**METROPOLITAN COAL PROJECT
RESPONSES TO SUBMISSIONS
PART A**

RESPONSES TO METROPOLITAN COAL PROJECT SUBMISSIONS

DECC – KEY ISSUES AND RECOMMENDATIONS

Figure 43 Low Flow Duration Curves for Lower Waratah Rivulet (Underflow Capacities of 0.5 ML/day and Sensitivity Analysis of 1.0 ML/day)

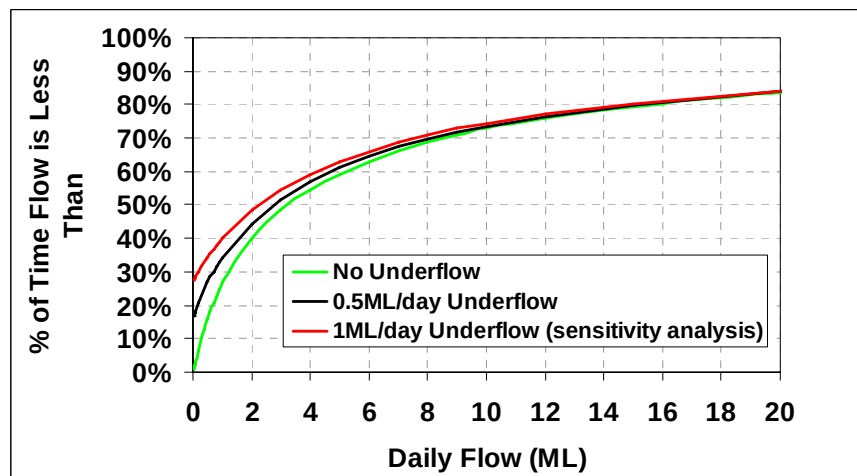
- a) *the link between subsidence effects, subsidence impacts and environmental consequences has not been fully or quantifiably assessed for the Waratah Rivulet, particularly for water-dependant species*

In Waratah Rivulet the amount of potential underflow as a result of the development of a fracture network has been conservatively estimated to increase the average frequency of no flow days as a result of the Project from 2% to 15% and increase the average frequency of low flows (less than 2 ML/day) from 36% to 40% of days (Appendix C). Mine subsidence associated with the Project would have a negligible effect (less than 0.5%) on moderate (approximately 10 ML/day) and larger flows. [These “potential underflows” are not lost from the system. Rather, they re-surface downstream of the zone of subsidence effects].

Additional detail, including a predicted flow duration curve for Waratah Rivulet is provided in Section 9 of Appendix C – extracts reproduced below:

There is extensive observational evidence that the fracture network can convey significant flows below the surface. At times when flow exceeds the hydraulic capacity of the network, surface flow will occur in these areas. Water level monitoring and water balance modelling suggest that the hydraulic capacity of the subsurface network may be in the region of 0.5 ML/day in some places. This fracture flow capacity estimate is considered conservative as it has been obtained from a water balance analysis of Pool A where the effects of subsidence are likely to have been greater than has been experienced in other pools due to its unique (large) size and because the downstream rock bar is thought to have been naturally more jointed than is apparent in the other pool rock bars on Waratah Rivulet.

All the investigations undertaken to date however show that subsidence induced underflow re-emerges downstream of the subsidence area with no evidence of flow loss to Woronora Reservoir.

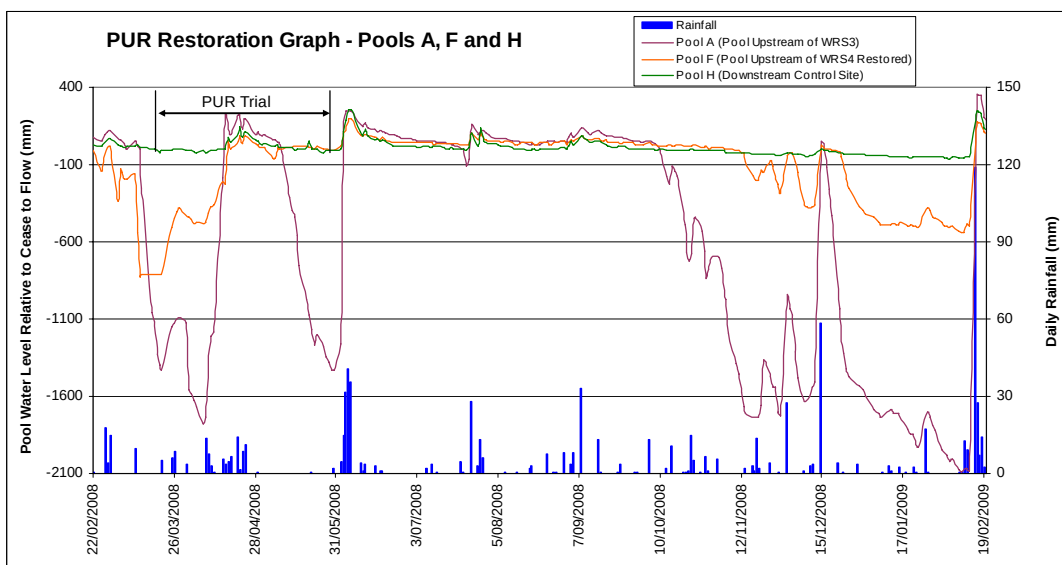
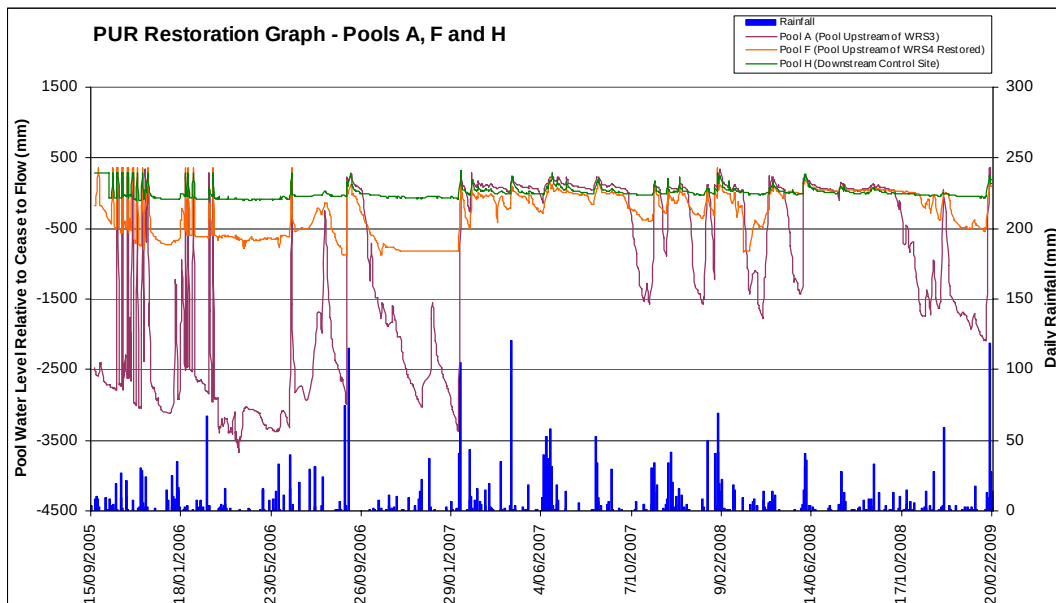
The WRS4 rock bar is still within an active subsidence zone. Movement is visually evident along the large diameter holes drilled for the stress relief slot. Recent survey results indicate 20 mm of subsidence in late 2008. This evidence indicates that additional subsidence has caused some near surface (<0.5 m) flow pathways to develop or a flow connection has established from fracturing along the stress relief slot.

Comparison of recorded water level behaviour in Pools A, F and H, both before and after the remediation trials at Pool F also provides a means of assessing the success of the trial. Water levels in Pool F were reportedly first affected during the longwall mining of Panel 12 in October 2005. Pool levels were further affected by mining of Longwall Panel 13. Water levels in Pool A were also affected by mining. Pool A has not been fully remediated and continues to show obvious signs of subsidence induced underflow.

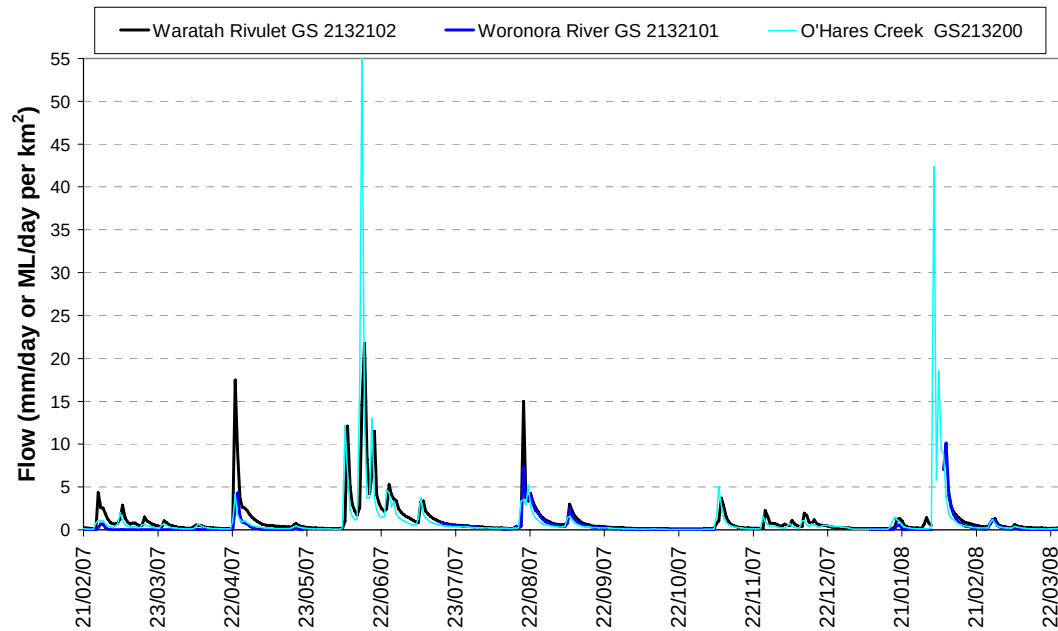
...

Many vertebrate species are known to utilise upland swamps, however many species are not dependent on this habitat type. However, a few species are dependent on upland swamp habitats (e.g. the Eastern Ground Parrot).

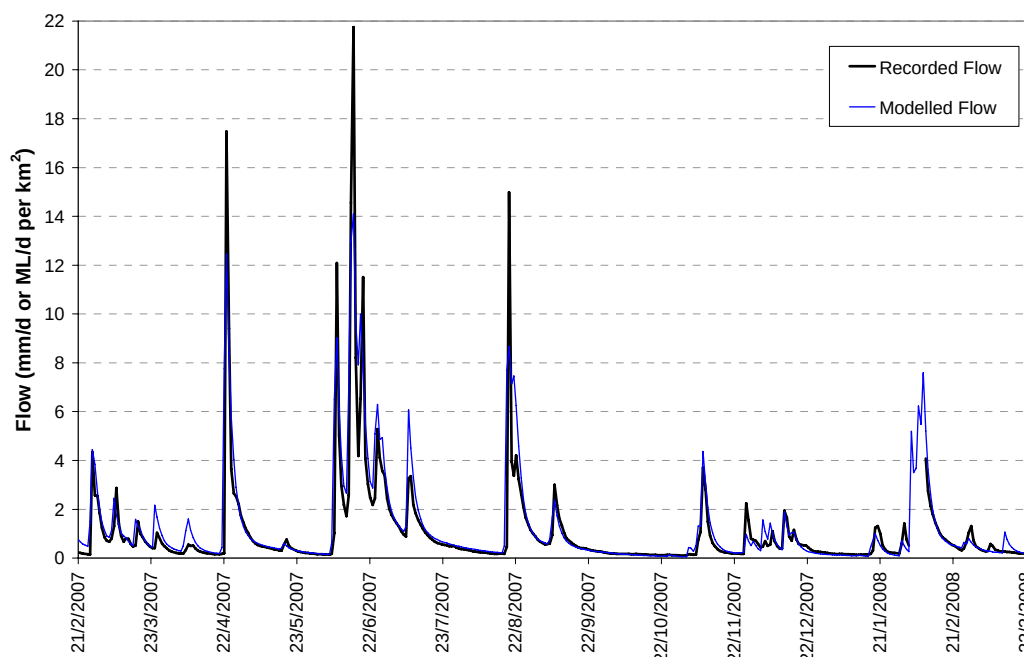
- Baseline terrestrial vertebrate fauna surveys were conducted for the Project in spring/early summer 2006 and autumn 2007 (Western Research Institute and Biosphere Environmental Consultants, 2008). Twenty fauna sampling sites were surveyed using a variety of methods including Elliott traps, cage traps, spotlighting, hair tubes, herpetofauna searches, bird surveys, call playback, platypus surveys, echolocation call detector systems, identification of faunal traces and opportunistic observations. Targeted surveys were conducted for threatened fauna species listed under the TSC Act and EPBC Act considered possible occurrences in the Project area and surrounds.

- As described above, targeted surveys were conducted for threatened flora and fauna species listed under the TSC Act and EPBC Act considered possible occurrences in the Project area and surrounds. In addition, a number of reference sources containing the results of local or regional flora and fauna surveys, database records and other scientific studies and literature were also reviewed. For example:

- Department of Environment and Climate Change (2007a) *Terrestrial Vertebrate Fauna of the Greater Southern Sydney Region: Volume 1 – Background Report; Volume 2 - Fauna of Conservation Concern including Priority Pest Species; Volume 4 – The Fauna of the Metropolitan, O'Hares Creek and Woronora Special Areas – Summary of Findings and Recommendations*. A joint project between the Sydney Catchment Authority and the Department of Environment and Climate Change.

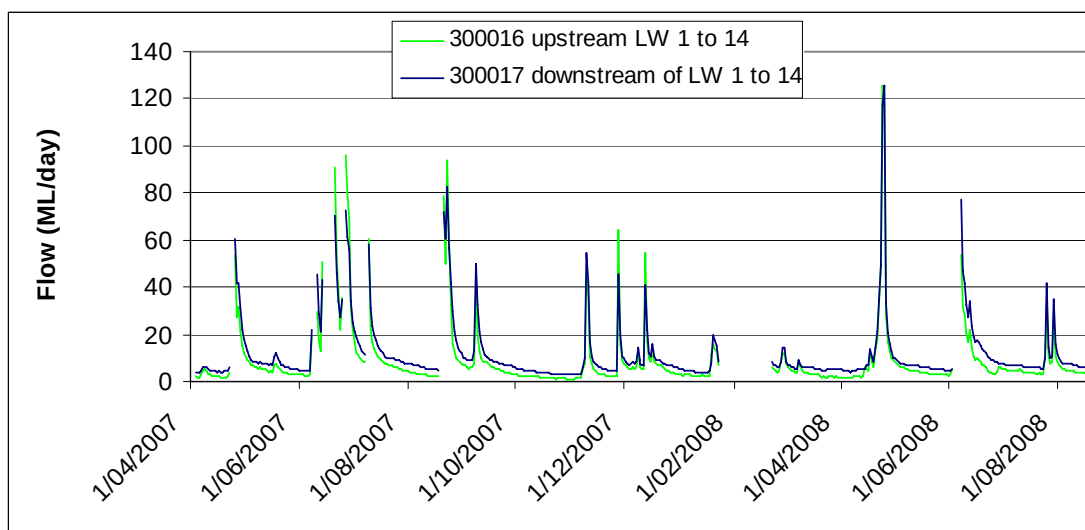
- a) A total of 188 sites have been recorded. The assessment of significance of the recorded sites has not been evaluated against any assessment criteria. Therefore the identification of sites as low, moderate and high is unsupported.**

In addition and as described in Section 4.8.2 of the EA, it is considered that the likelihood of direct damage to Aboriginal heritage sites is low.

Appendix A also notes that although impact is possible, based on experience in the Southern Coalfield, the likelihood of significant impact on sandstone overhang sites as a result of mine subsidence is also low.

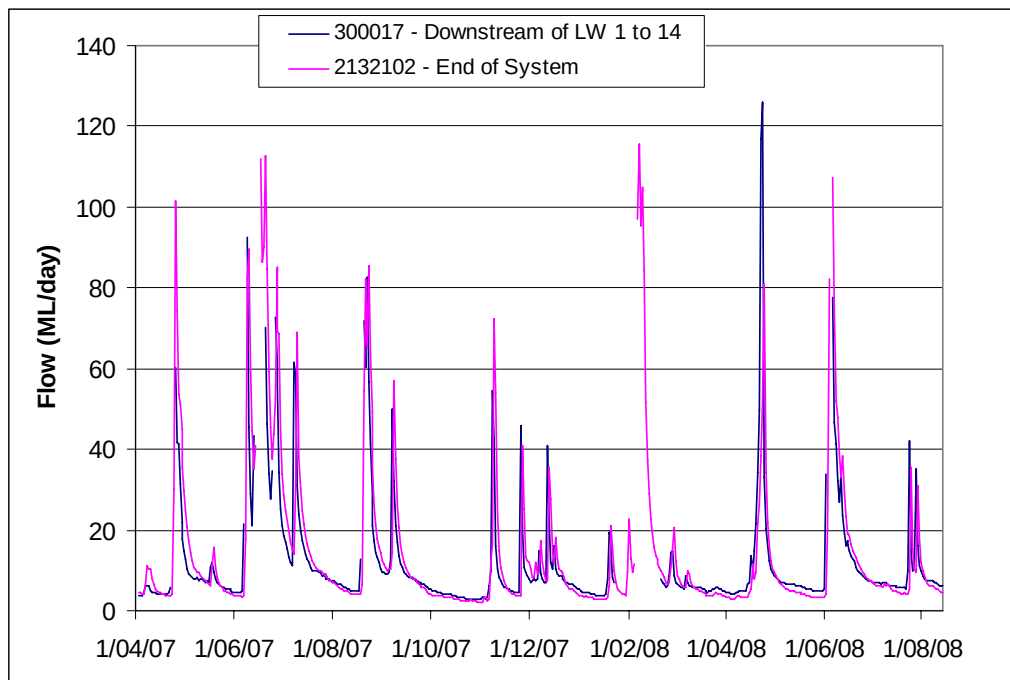
Appendix A states that:

Monitoring of approximately 41 Aboriginal heritage sites (subject to mine subsidence) has been undertaken between 1995 and 2008 at the Metropolitan Colliery. Of the 41 sites monitored, 21 had maximum predicted tensile or compressive strains greater than 0.5 mm/m and/or 2 mm/m respectively.

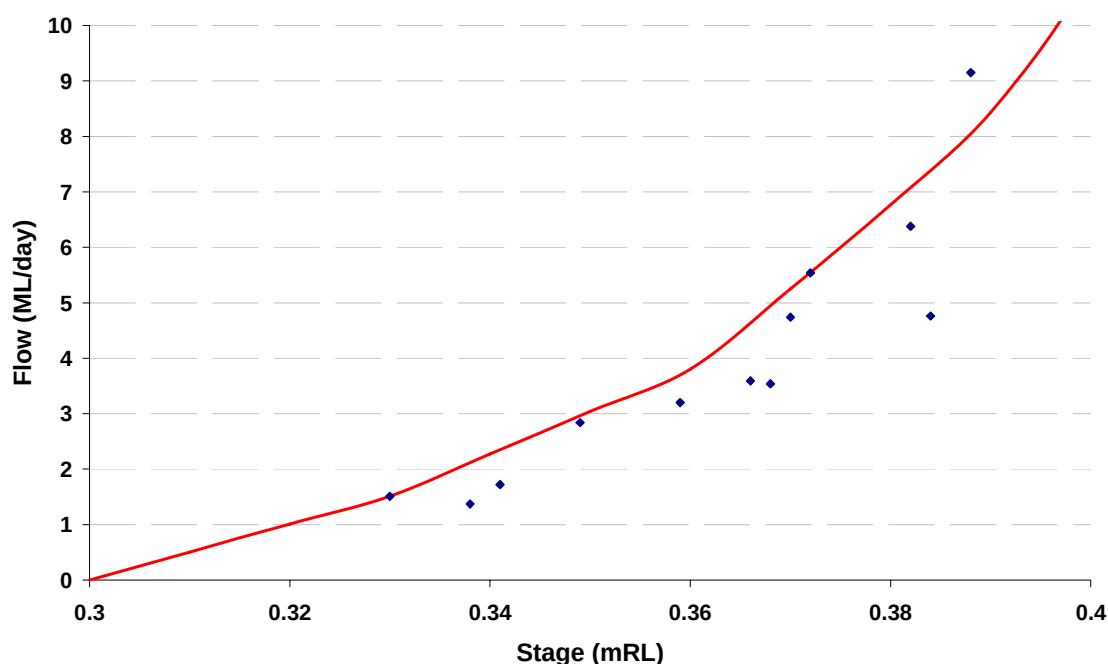
Sections 9 and 10 of the ACHA also recommend that all sites of high archaeological significance and all sites of particular cultural significance (as identified by the Aboriginal community) be considered (by HCPL and the Aboriginal community) for developing and implementing mitigation measures.

Archaeological significance was assessed and assigned on a three tier (as opposed to a five tier) bases to avoid complication when applying relevant management/mitigation measures. In this regard, the assigned archaeological significance is conservative as any site that may have been assigned a ‘low-moderate’ rating on a five tier system was assigned a full ‘moderate’ rating and therefore subject to all management measures proposed for sites of moderate archaeological significance. Similarly, sites that may have been assigned a ‘moderate-high’ rating on a five tier system were assigned a ‘high’ rating and therefore subject to all management and mitigation measures proposed for sites of high archaeological significance.

“Aboriginal heritage sites provide evidence of our ancestry and links to past occupation. TLALC considers all Aboriginal heritage to be important to our people”.

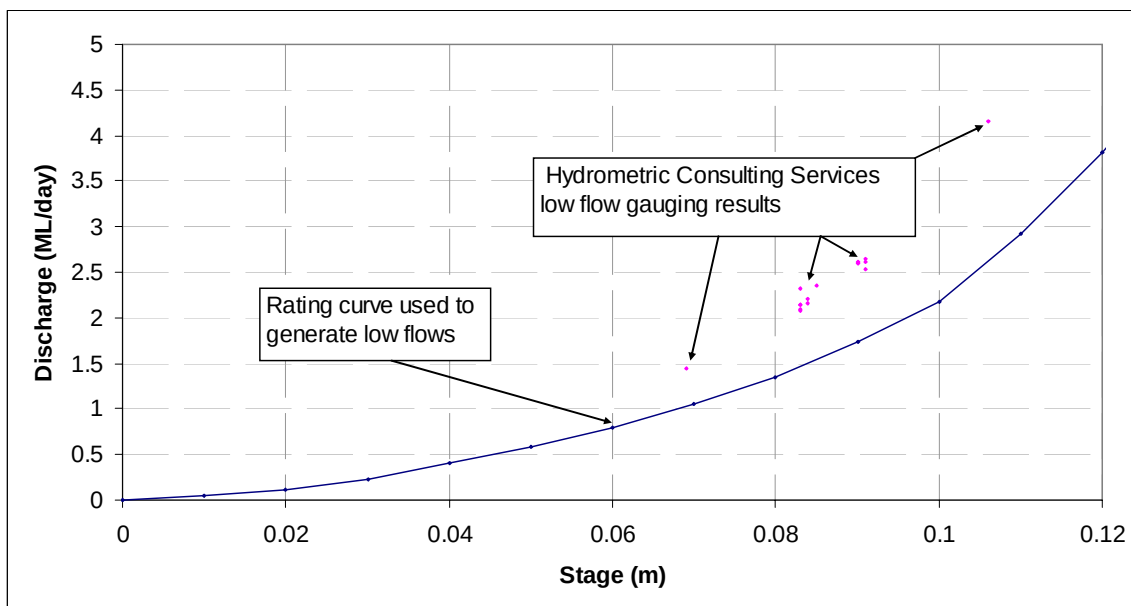
- c) *There is no consideration of the area as a cultural landscape and therefore how a significance assessment would take this concept into account. It needs to be borne in mind that sites from a continuous series of activity and occupation events across the landscape and that one site is part of an overall picture of life.***

All these sites are important because they collectively represent the lives and culture of past people – the material remains. Such evidence of the vibrant lives of these peoples is also important spiritually, culturally, and scientifically to any humane and progressive society ...”.

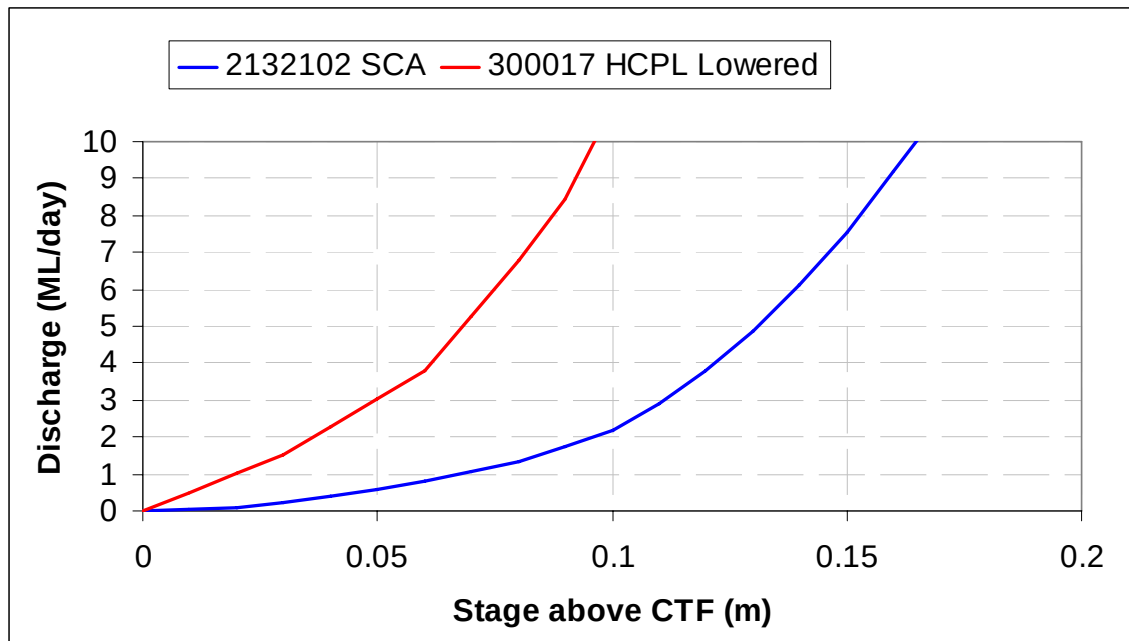
- d) *No information provided on the quantitative link between subsidence impacts and consequences to Aboriginal sites of significance.***

In addition, Section 8 and Appendix 6 of the ACHA provide the predicted subsidence movements (as assessed by MSEC) for each Aboriginal heritage site within the study area. This information allows the identification of every Aboriginal heritage site within the study area which MSEC has predicted may potentially be impacted by subsidence movements.
